Re: Administrative Order 2RF-219
PLU Row 2 West Recycling Containment Variance Request
Facility ID (fVV2507951055)

XTO Permian Operating, LLC (OGRID: 373075) respectfully requests a variance to the approved C-147 application package for the PLU Row 2 West Recycling Facility Containment (frac pond) Permit 2RF-219 Recycling Facility ID (fVV2507951055).

FENCE DETAILS
OF
PROJECT NAME: POKER LAKE UNIT ROW 2
WEST FRAC POND

2 END POST
N.T.S.

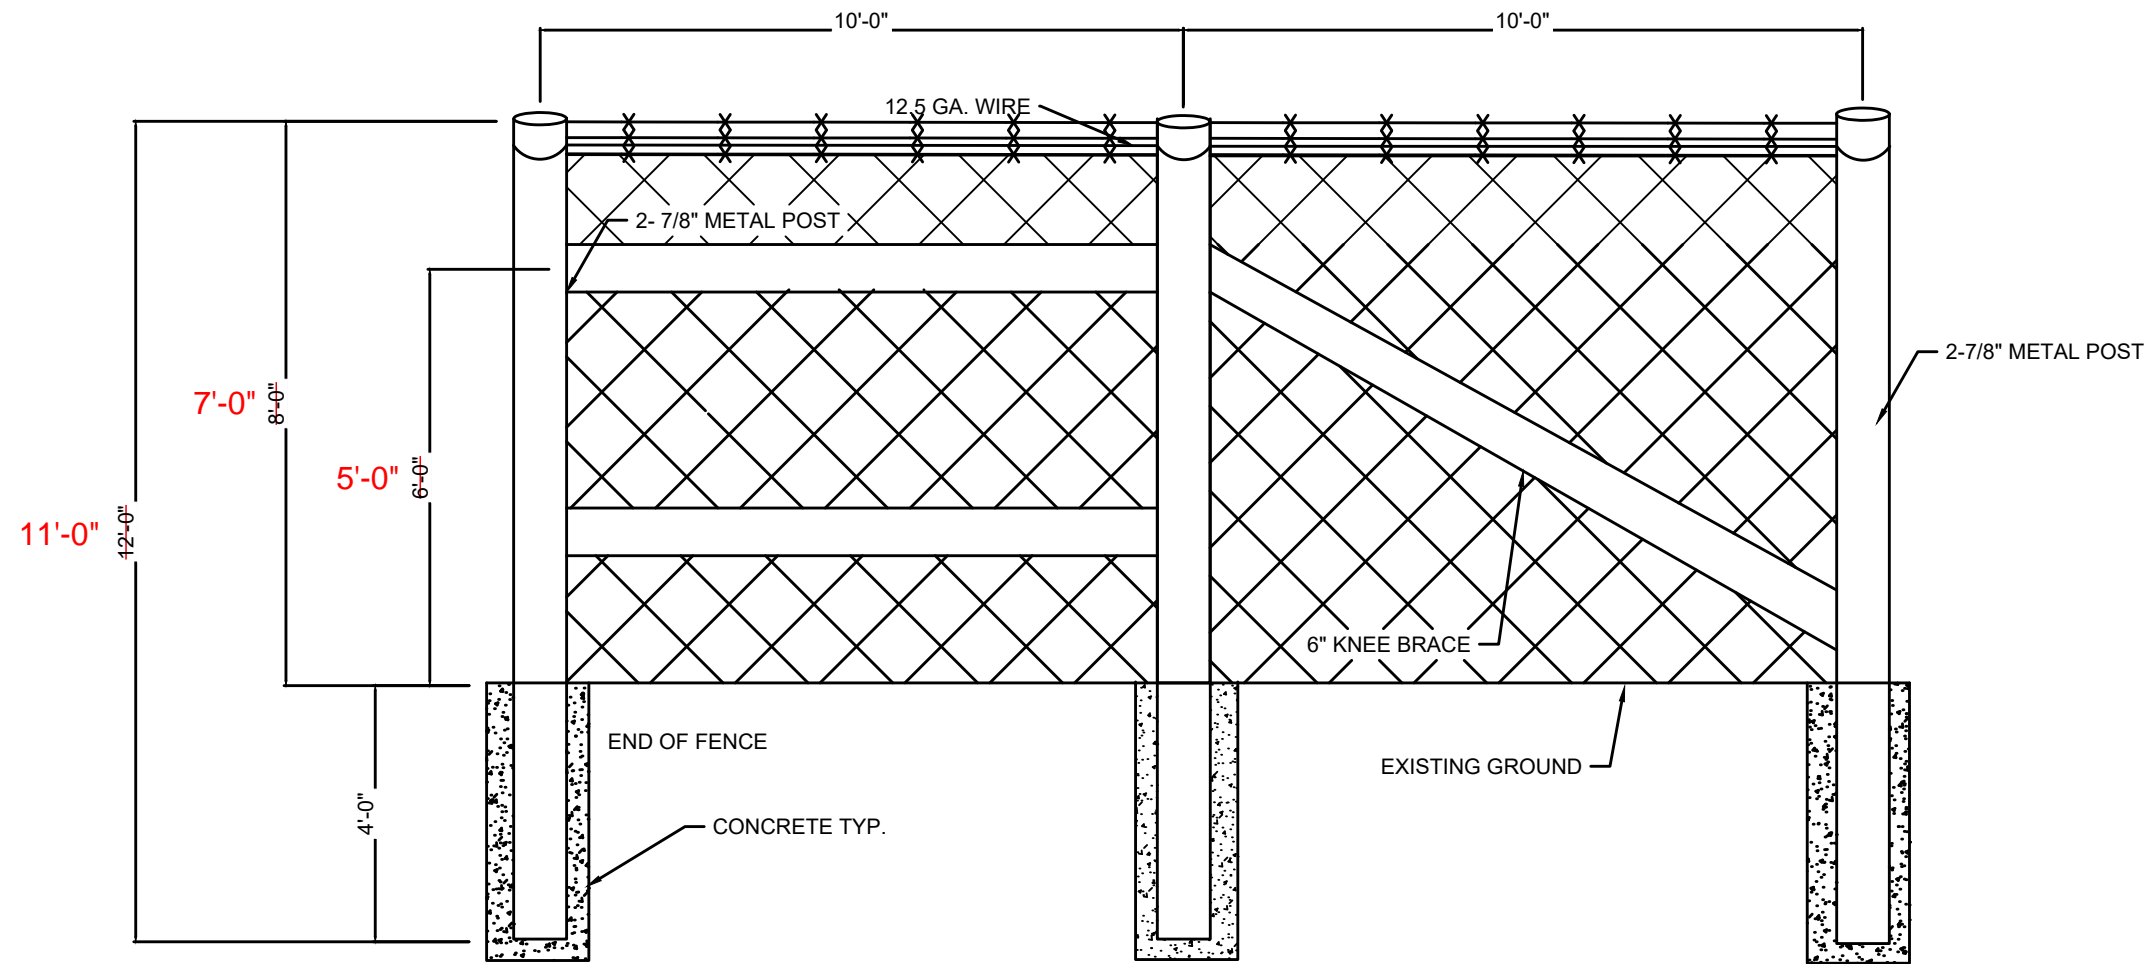
Due to a construction oversight, the originally specified fence height of 8 ft. was not achieved. The as-built fence height is 7 ft. XTO Permian Operating, LLC respectfully requests a variance to the as-approved C-147 application package to incorporate the as-built fence height of 7 ft.

The originally submitted engineered fence drawings can be seen in "CS-503.pdf" (attached). The redlined fence drawings can be seen in "CS-503-redlined.pdf" (attached).

- The modification request to the approved variance to install a wire mesh, game fence, seven (7) feet in height, instead of the originally permitted fence height of 8 ft is approved.
